## **ADDENDUM NO. THREE (3) ILM TERMINAL IMPROVEMENTS CONTRACT 3**

Date: July 30, 2019

RE: ILM Terminal Improvements Contract 3

From: The Wilson Group  
PO Box 5510  
Charlotte, NC 28299

SHEET NUMBER  
**A2-731**

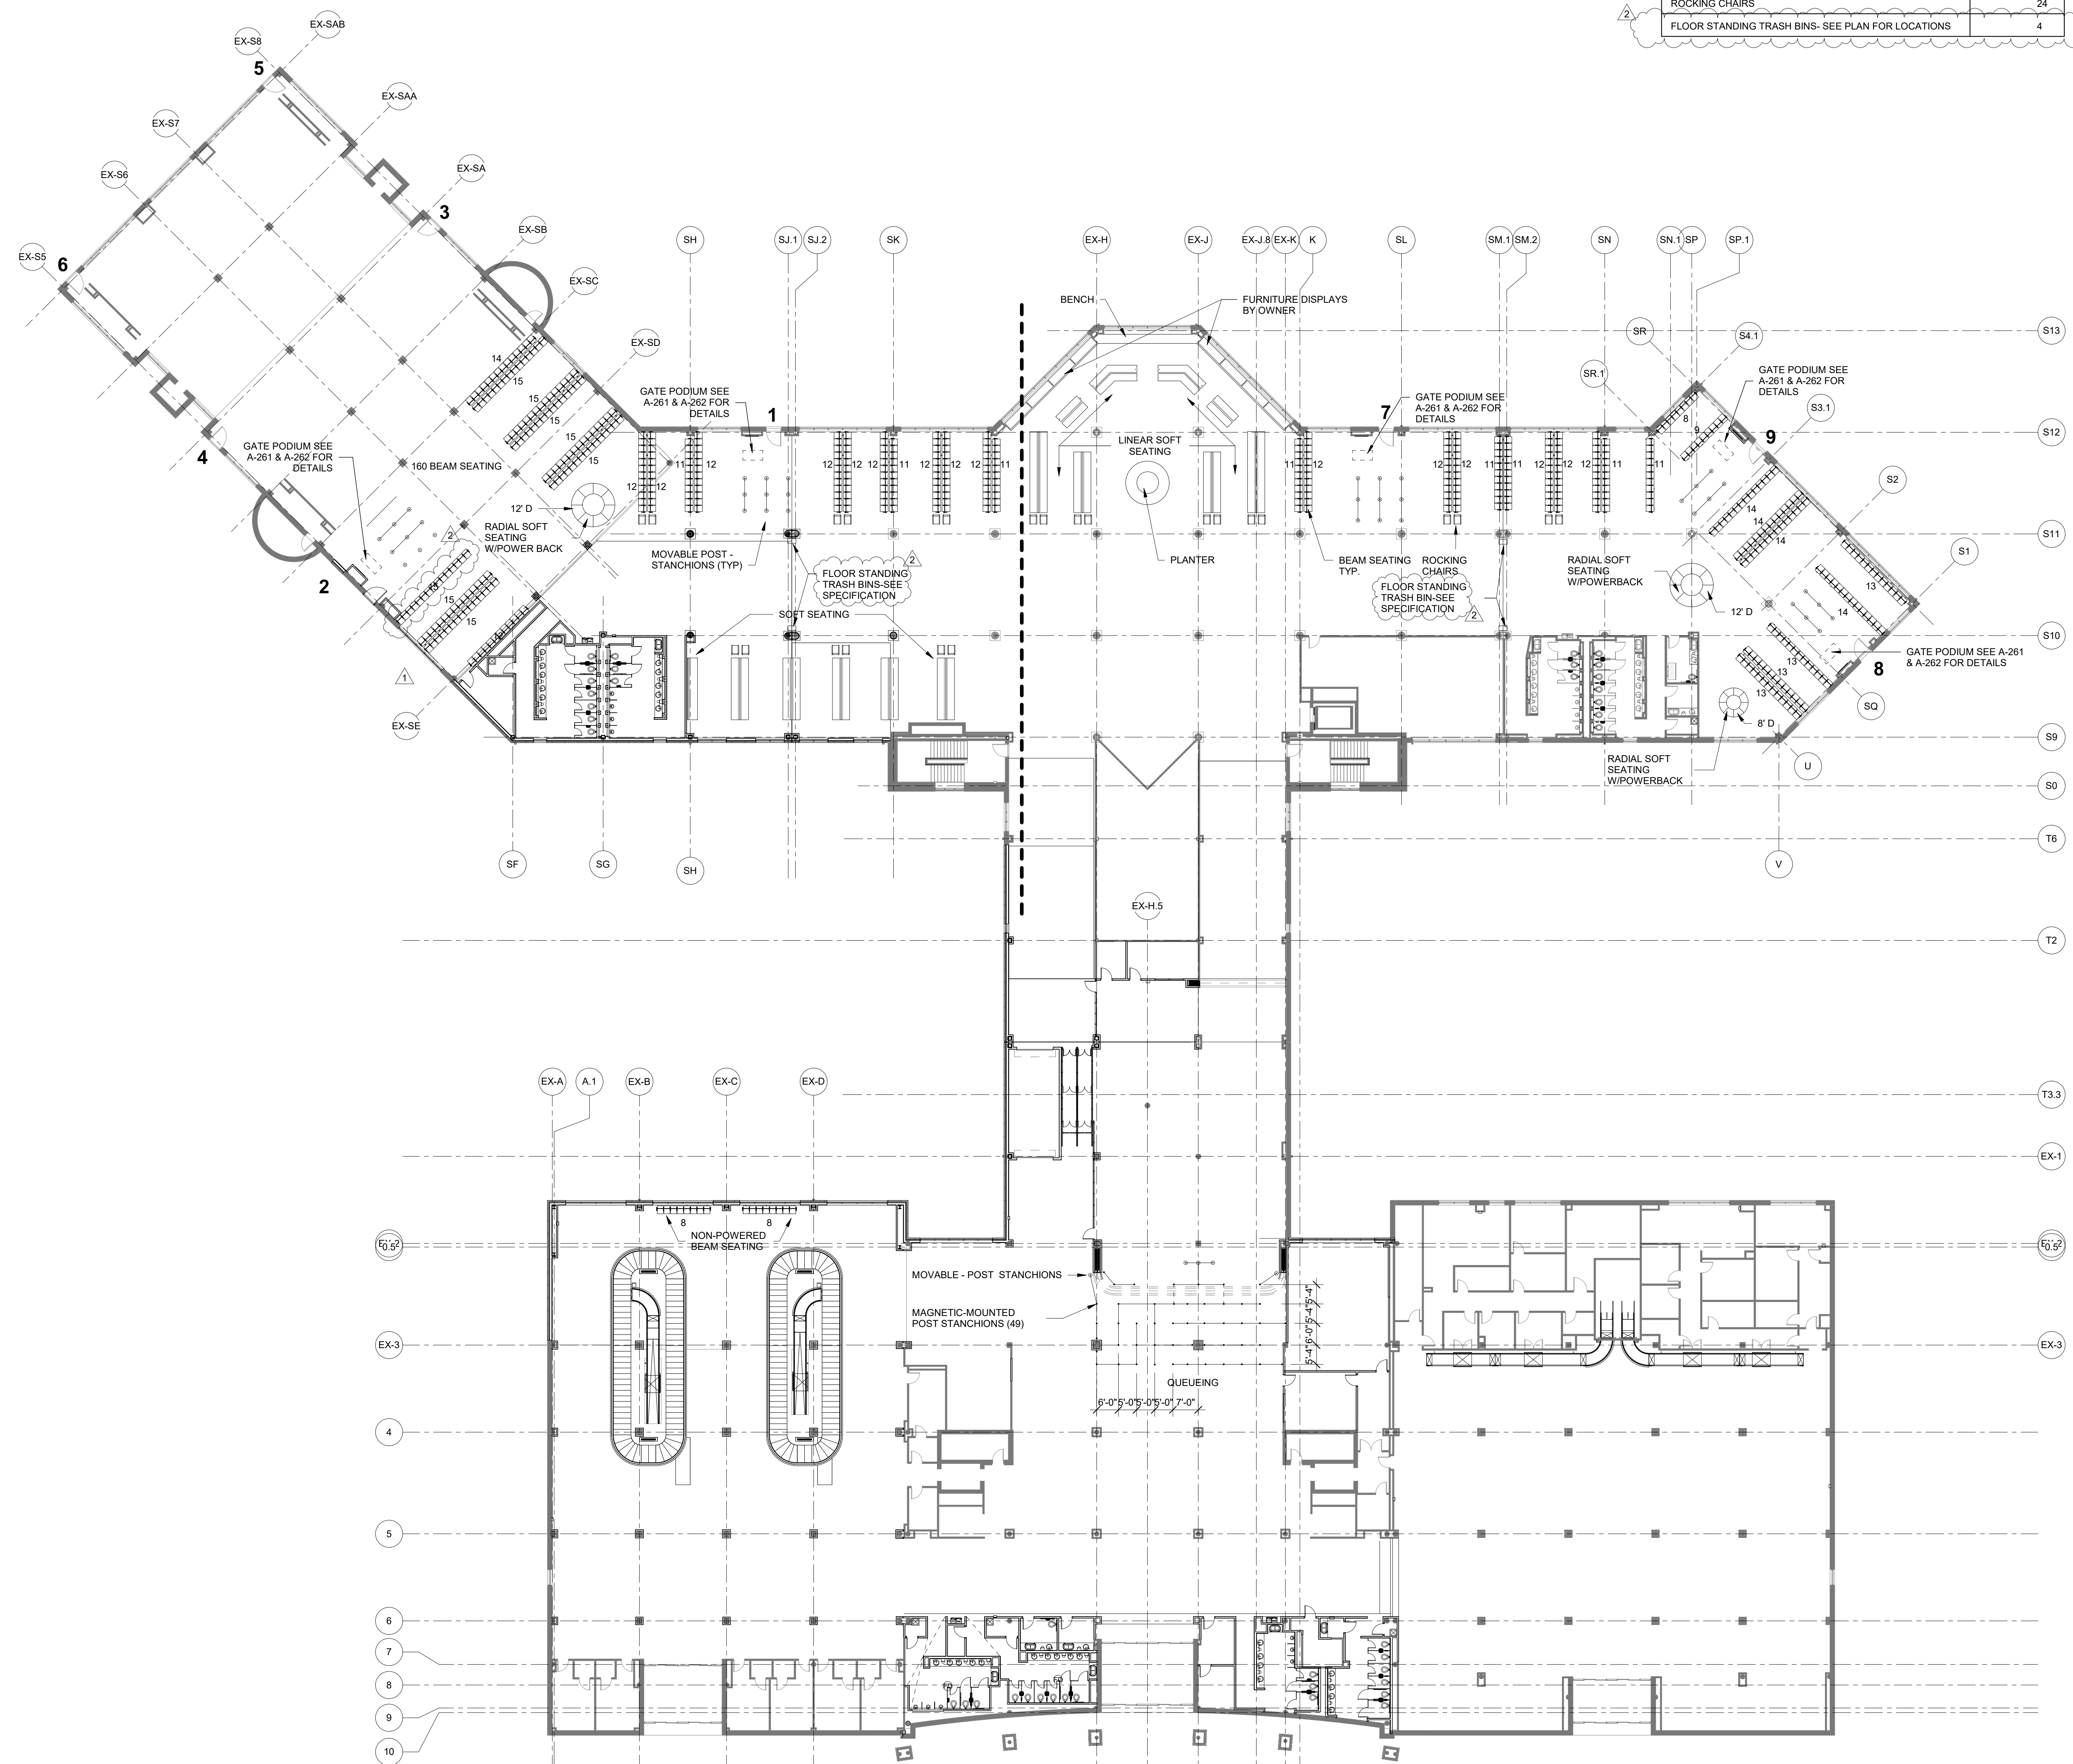
- lll. A2-731 SCHEDULE 2 – BOARDING LEVEL FURNITURE PLAN (AD-03). *Note: Added waste receptacles and updated furniture quantities.*
- mmm. A-503 PLAN DETAILS (AD-03). *Note: Revised gate wall detail.*

**P1-112**

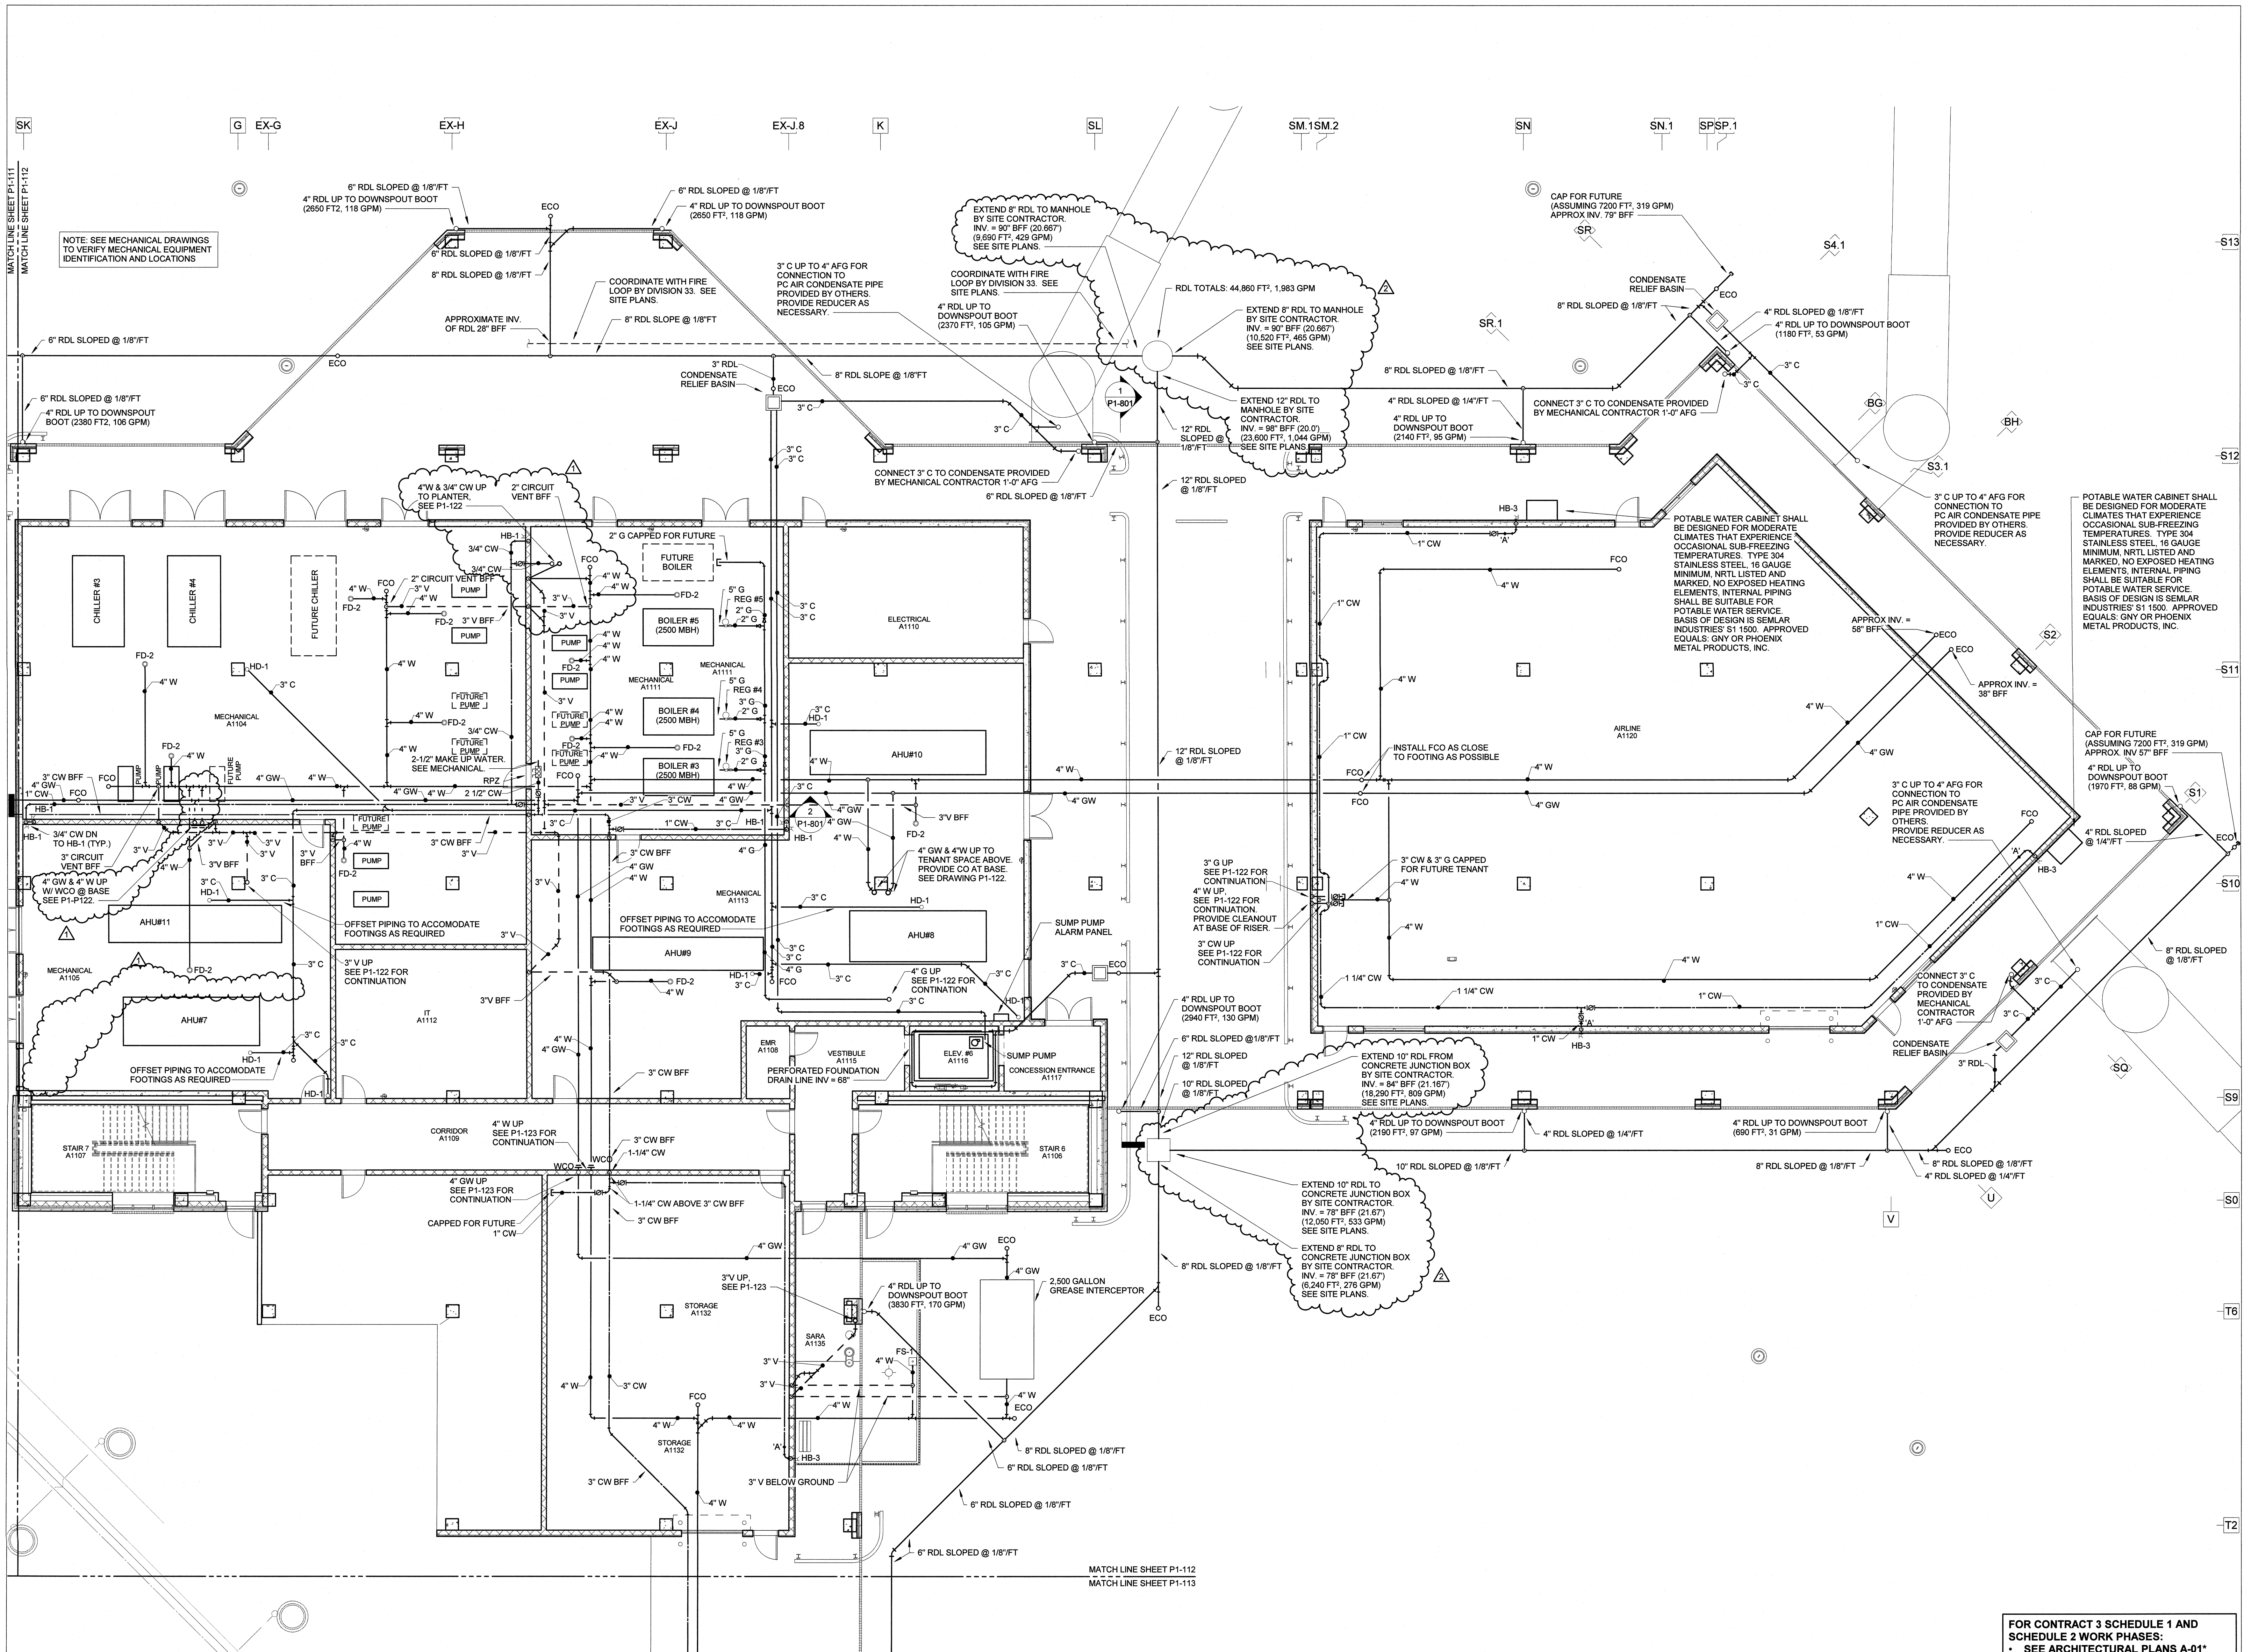
- vvv. P1-112 SCHEDULE 1 – RAMP LEVEL PLAN ZONE 2 PLUMBING (AD-03). *Note: Adjusted roof drain leader invert elevations and coordinated with site plans.*

**E2-111**

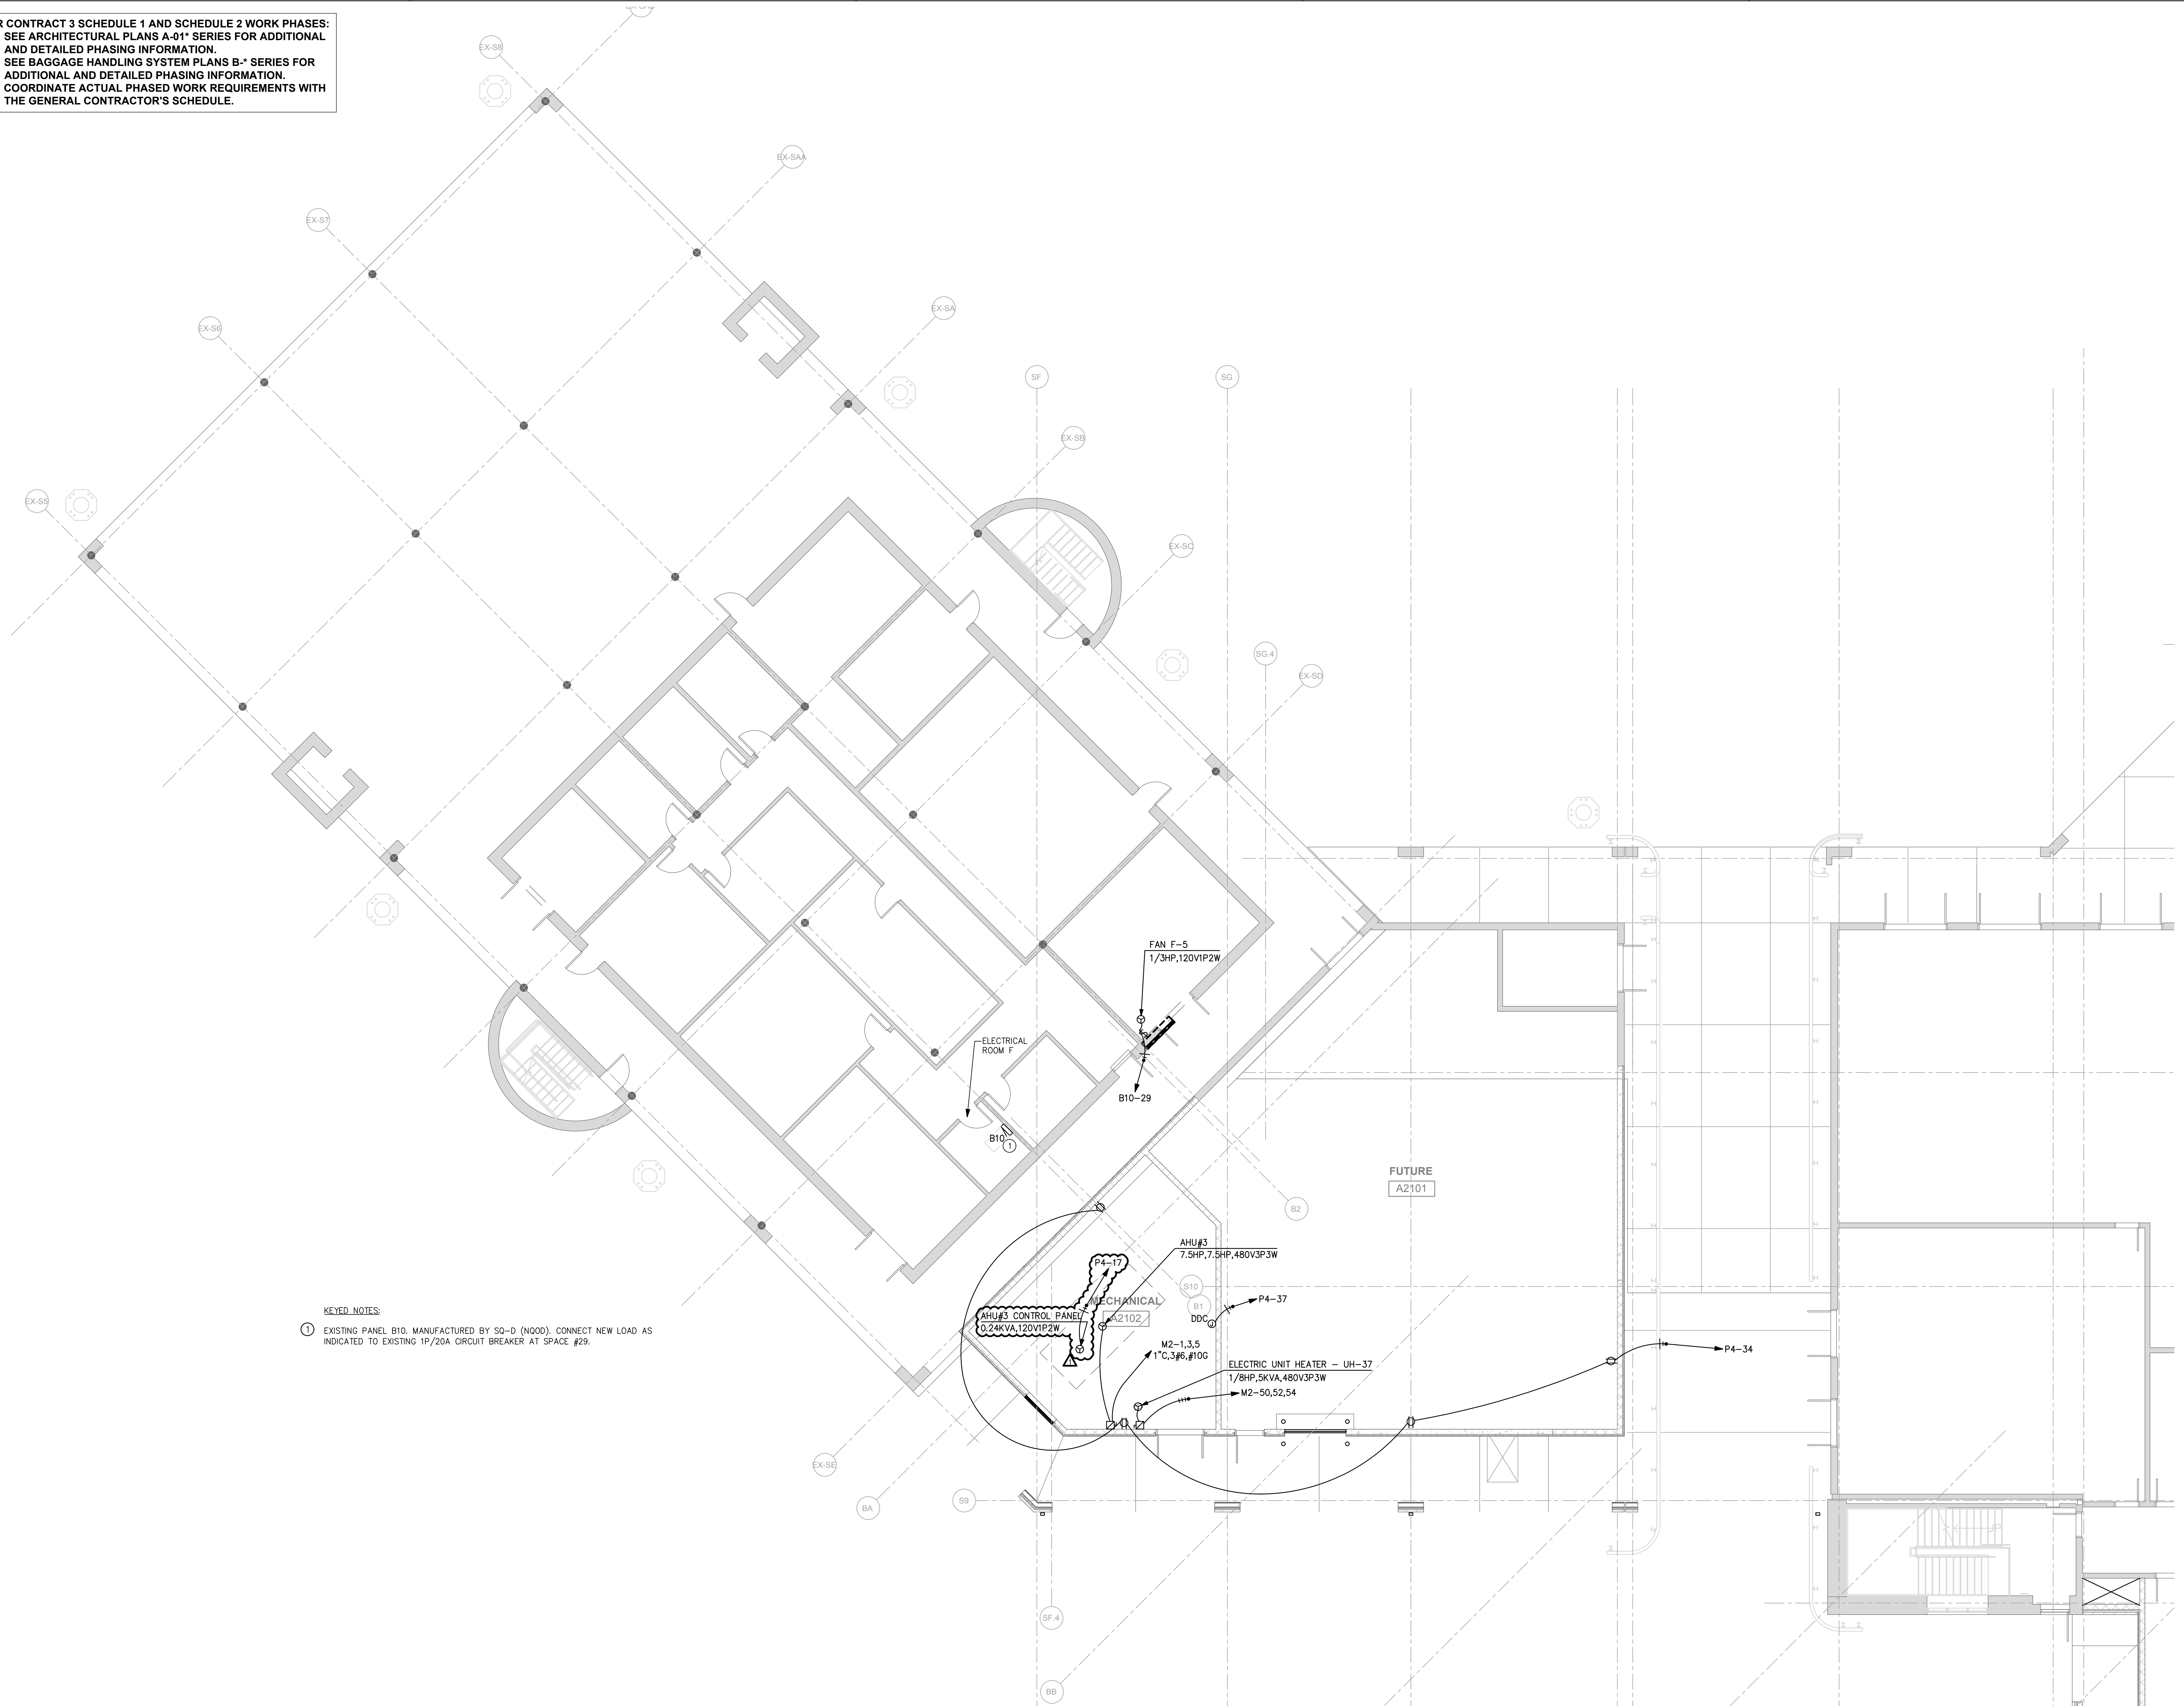
- rrrr. E2-111 SCHEDULE 2 – ELECTRICAL RAMP LEVEL POWER PLAN ZONE 1 (AD-03). *Note: Added power control panel integral to AHU #3.*
